RUGER® SR9® PRODUCT SAFETY WARNING AND RECALL NOTICE

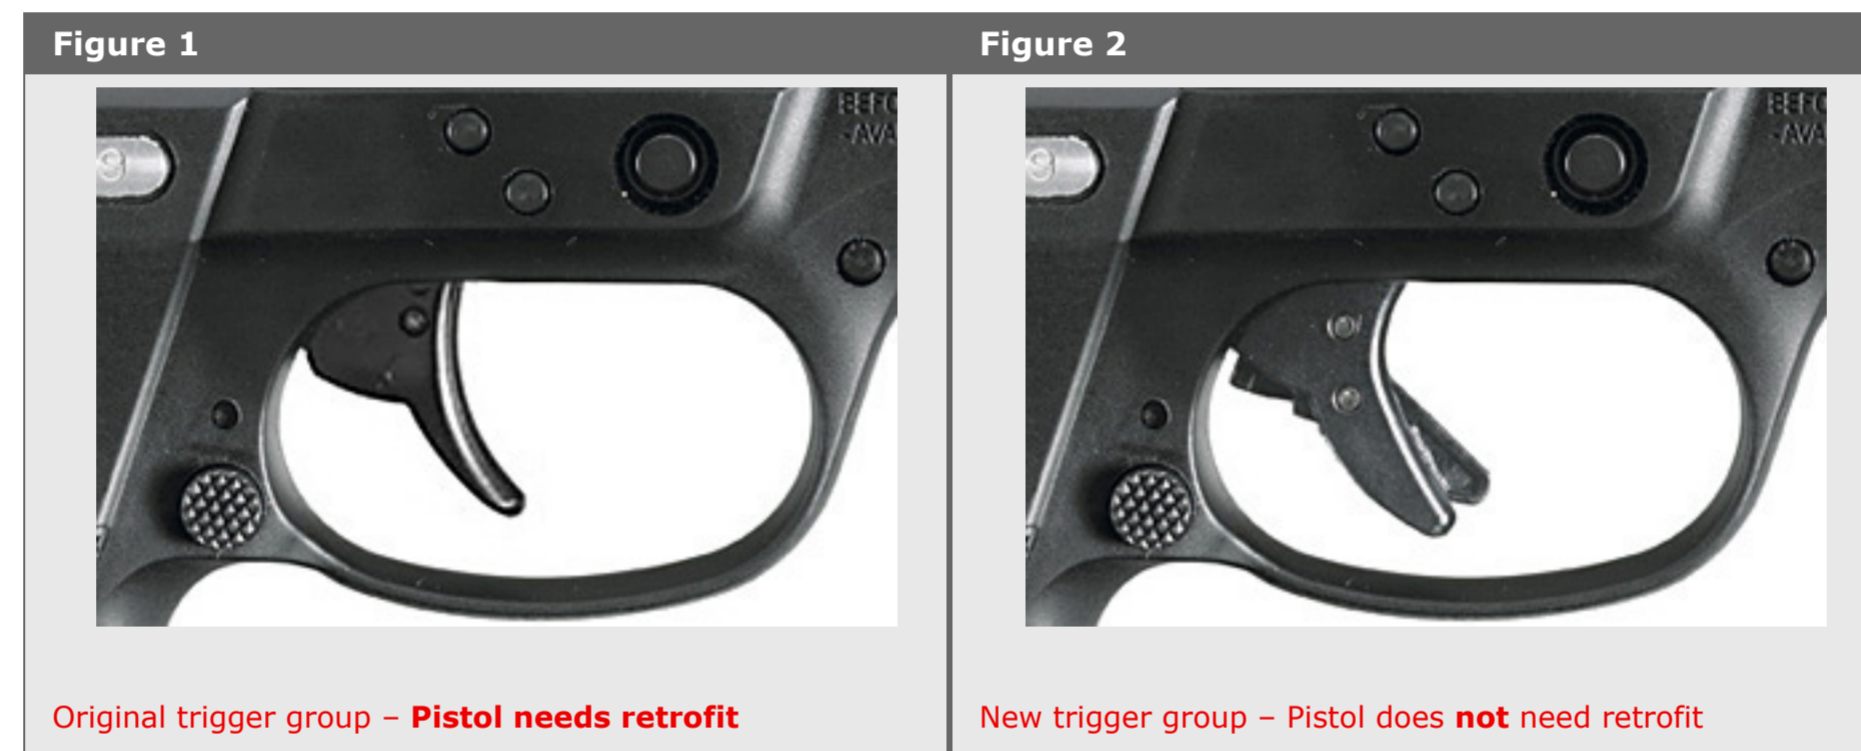
We have determined that some Ruger® SR9® pistols manufactured between October 2007 and April 2008 could, under certain conditions, fire if dropped with their manual safeties in the "off" or "fire" position. The pistols will not fire if the manual safety is in the "on" or "safe" position.

It is easy to determine if your pistol has been retrofitted by simply looking at it. Although both the old and new trigger group have a two-stage trigger, the original design had an inner "shoe" that was not visible and, therefore, appeared to be a single trigger (See Figure 1). The new trigger design incorporates a visible inner trigger of a blade design (See Figure 2).

Step 3 - We will install the new trigger group in your SR9® and return it to you FREE of charge.
